# 1965 Corvette: Service News: Vent the Window Regulator Motor

**Source:** Chevrolet Service News

**Date:** December, 1965 - Volume 37 - Number 11

**Fig. 1—Installing Window Regulator Motor Lower Attaching Screw (Vented)**

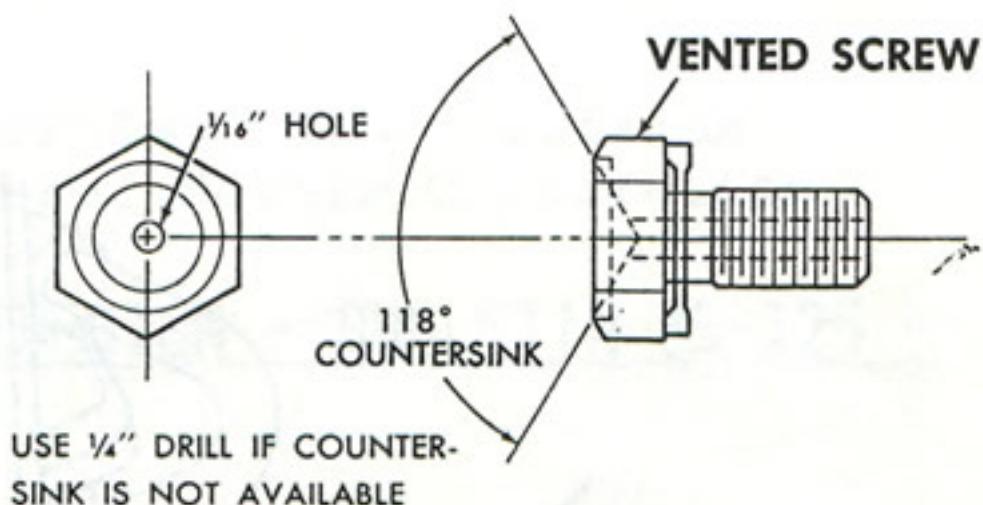
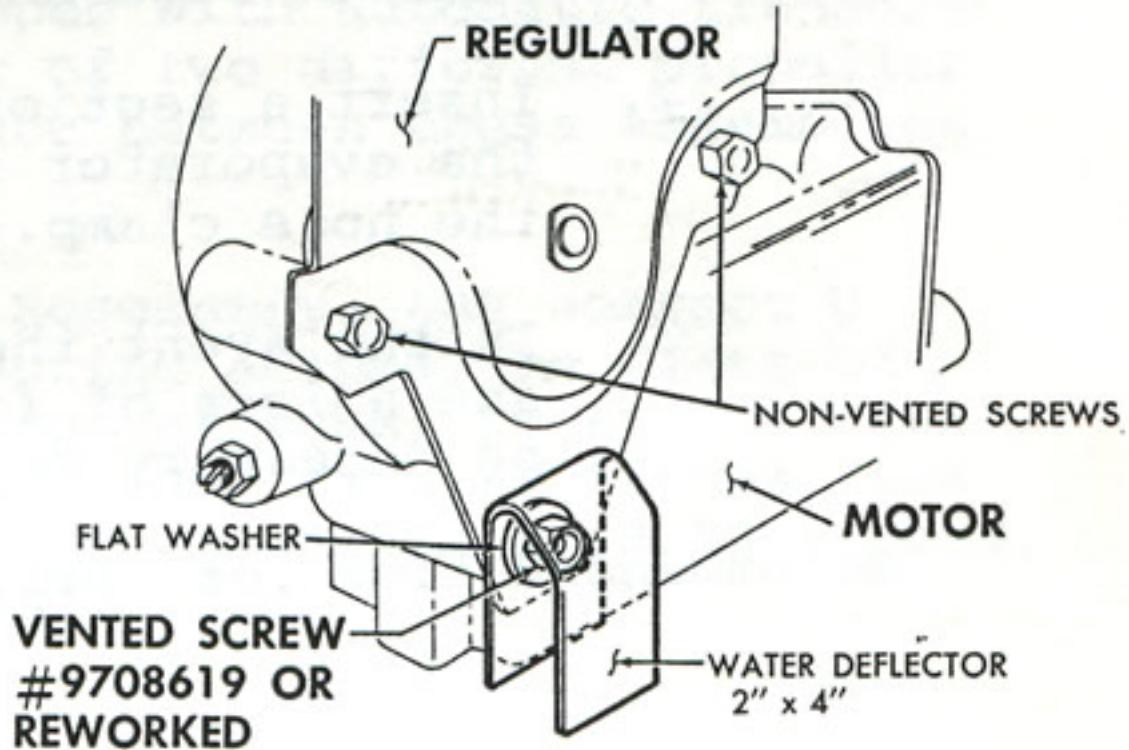
Refer to article "Replacing Window Regulator Motor", on the last page of November issue of Service News for door window regulator motor replacement . . . and before completely replacing the motor, the lower attaching screw should be drilled through (hollow) to vent the motor (See Fig. 1). Venting the motor on all replacement motors will improve the reliability of power window motors.

**IMPORTANT:** *The screw to be vented is the lower one of the three screws. The motor housing is cored to permit air to enter motor interior only at this one location.*

**NOTE:** *If vented screw Part No. 9708619 is not available, drill a 1/16" hole through the center of one of the motor to regulator attaching screws and countersink the head of the screw (Refer to Fig. 1). Drill hole starting at threaded end of screw.*

Construct a water deflector, 2" x 4" with a 1/4" hole 1-1/4" from one end, from suitable water repellent material.

Production now incorporates this change.
